Access Compliance Report Public Rights-of-Way (Curb Ramps)

Intersection ID: 10029072 Main Street: IVERSON WY **Cross Street: N/A** Location: ADA ID: B959010084C0 Ramp Type: BlendTrans2 Initial Pass/Fail: Pass **Overall Compliance: No Severity Score:** 15

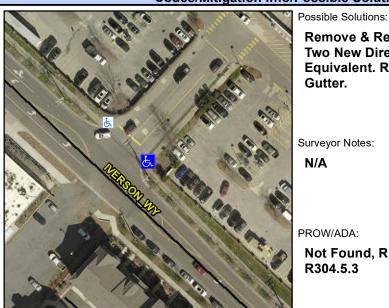
ENTRANCE Street 1 Name Stop Condition-Street 1 StopSign Street 2 Name N/A Stop Condition-Street 2 N/A Remove & Replace Curb Ramp With Two New Directional Ramps or Equivalent. Remove & Replace Gutter.

Not Found, R305.2, R302.7.2, R304.5.3
